# Access Compliance Report

## Public Rights-of-Way

Intersection ID: 10572	Main Street: GRIMES_ST	Cross Street: SYLVANIA_AV	Location: S
ADA ID: 2DA3F708C825	Ramp Type: Perp	Initial Pass/Fail: Fail	Overall Compliance: No
			Severity Score: 21.25

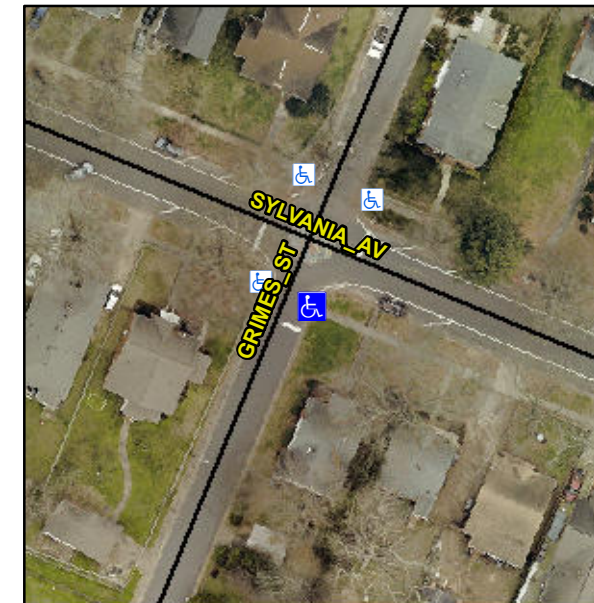
**Not Found, R304.5.1, R304.2.2**

Compliance	Description	Data	Compliance	Description	Data
N/A	Ramp Length (in)	52.5	No	Ramp Slope (%)	11.2
No	Ramp Width (in)	46.5	Yes	Ramp XSlope (%)	2.0
N/A	Flare Type LT	N/A	N/A	Flare Type RT	N/A
N/A	Flare Slope LT (%)	N/A	N/A	Flare Slope RT (%)	N/A
N/A	Flare Traversable LT?	N/A	N/A	Flare Traversable RT?	N/A
N/A	Landing Length (in)	N/A	N/A	DWS Provided?	N/A
N/A	Landing Width (in)	N/A	N/A	DWS Contrast?	N/A
N/A	Landing Slope (%)	N/A	N/A	DWS Length (in)	N/A
N/A	Landing X Slope (%)	N/A	N/A	DWS Full Width?	N/A
N/A	Landing Curb? (Y/N)	N/A	N/A	DWS Offset (in)	N/A
N/A	Shared Landing?	N/A			
N/A	Gutter Ponding?	N/A	N/A	Gutter Slope (%)	N/A
N/A	Gutter Lip Ht (in)	1.0	N/A	Gutter X Slope (%)	N/A
N/A	Painted X Walk1?	No	N/A	Painted X Walk2?	N/A
	X Walk 1 Direction	To NW		X Walk 2 Direction	N/A
N/A	X Walk 1 Width (in)	N/A	N/A	X Walk 2 Width (in)	N/A
	X Walk 1 Slope (%)	2.3		X Walk 2 Slope (%)	N/A
	X Walk 1 X Slope (%)	1.2		X Walk 2 X Slope (%)	N/A

**Remove & Replace Entire Ramp.**
